Memorandum

Message Ref: KiwiRail Regional Freight Hub NoR – S92 response Ecology

Project No: BM200256

Figure 2

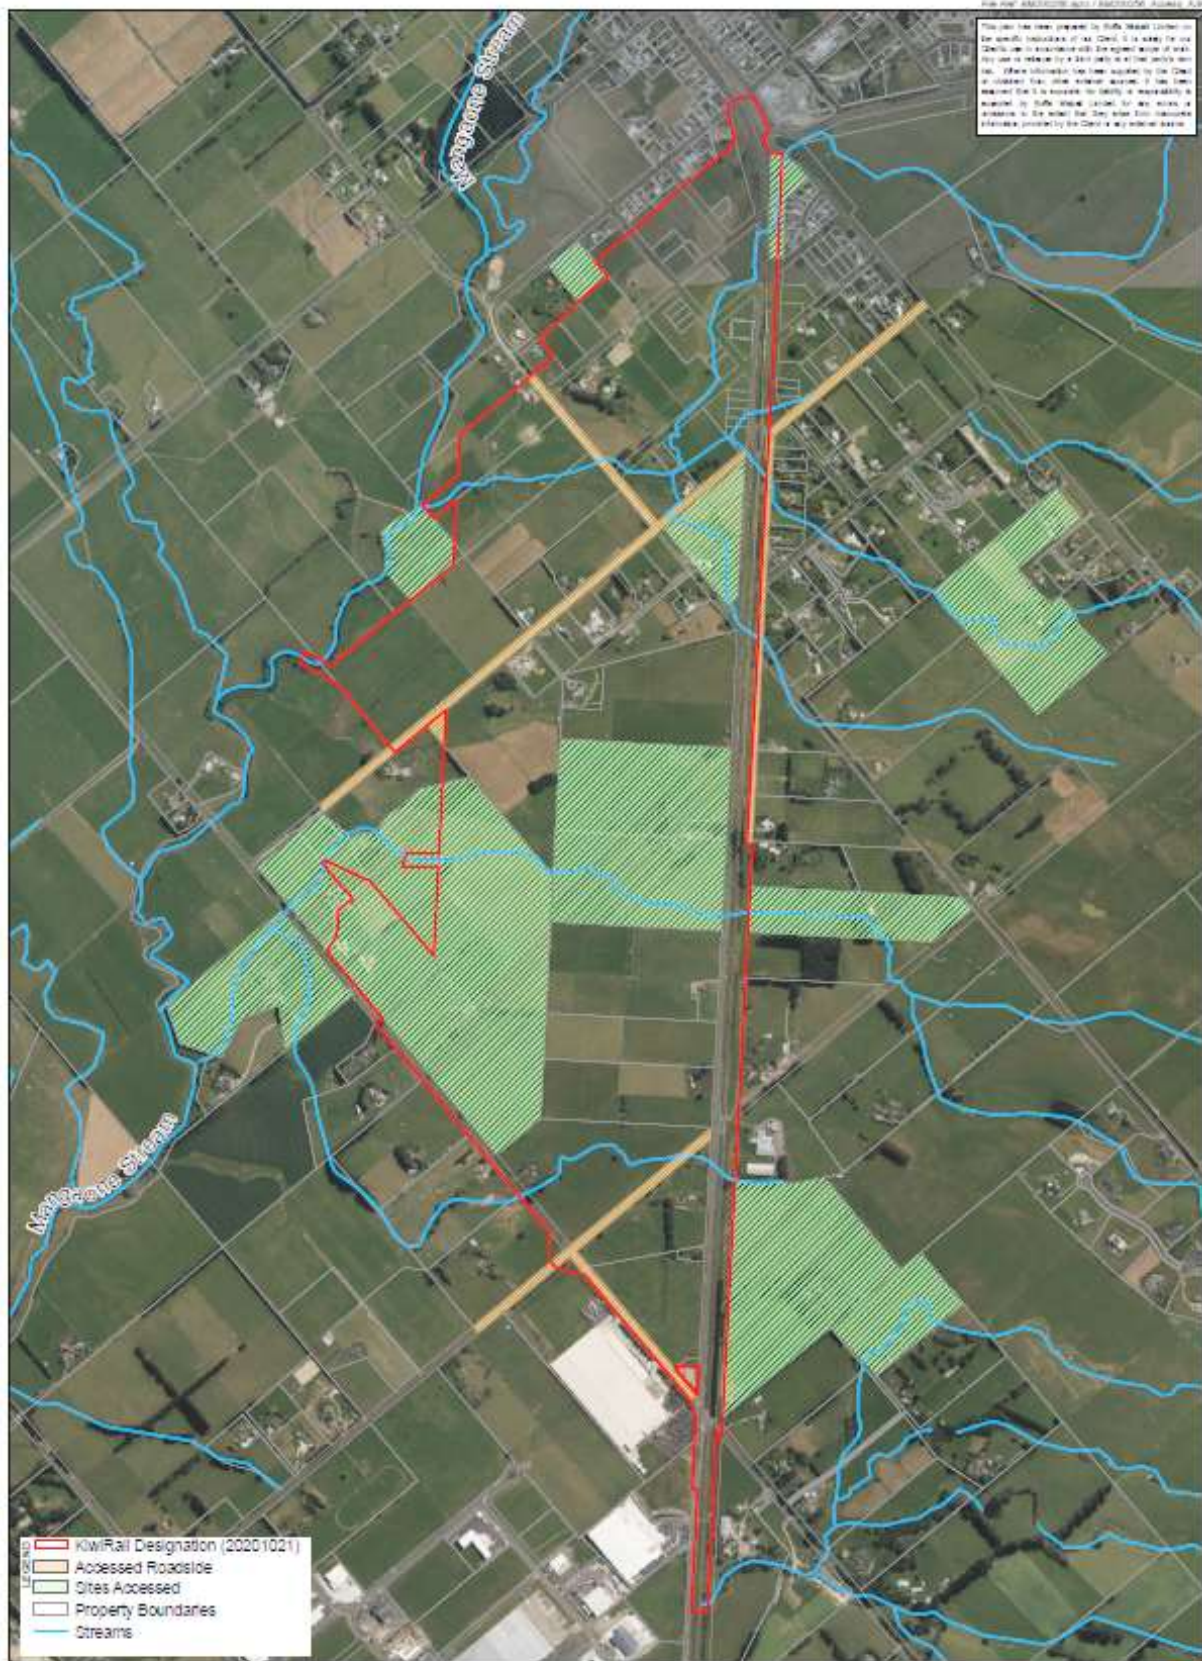
<p>72) <i>Please clarify the approach taken to classifying streams and provide further information as to the justification for the classification and values of streams that have not been visually inspected and, where appropriate, identify whether or how any uncertainty pertaining to affected stream length and values has factored into the assessment.</i></p>	<p>The AEE states that the definitions within the Auckland Unitary Plan were referred to (page 9) however, the descriptions of the streams and the associated photos do not align with these definitions. For example, an ephemeral stream always has its bed above the water table, however Image 1 shows an 'ephemeral stream' which has water present. Conclusions are drawn that the entire Stream 1</p>	<p>The ecological valuation of aquatic systems is a synthesis of site data and other information, drawn from a range of sources and criterion (such as those contained in the EIANZ guidelines) and the classification of a stream into one of three hydrological regimes is of minor importance and does not always reflect a particular value.</p> <p>As discussed in Technical Report F – Assessment of Ecological Values and Effects, the One Plan does not contain stream classification definitions. As such, the Auckland Unitary Plan definitions were developed for</p>

ECOLOGY	REASON FOR QUESTION	RESPONSE
	<p>catchment is ephemeral, based on the small amount of stream length that could be accessed. When comparing the size of this catchment (623ha) and adjacent catchments (including the central perennial 'Northern tributary', with a catchment area of 596ha), it is expected that at least some of the stream is intermittent or permanent. The stormwater report identifies that much of the stream length is activity eroding (page 8), suggesting flows may be more than ephemeral. Further, some stream length appears to have been excluded from the site maps.</p>	<p>permanent (commonly called perennial), intermittent, and ephemeral streams/reaches and applied in the context of landscape and the One Plan objectives and policies. Appendix 1 includes the relevant definitions and how these have been interpreted and applied.</p> <p>Following a further site visit in January 2021, we have reclassified the northern most branch of Stream system 1 as intermittent but retained the other branches as ephemeral. These changes do not alter the overall valuation and outcomes of the ecological impact assessment. There are still sections of this system (particularly downstream of the various confluences) that we have not been able to visit and have therefore not classified. These changes are portrayed in Figure 2.</p>
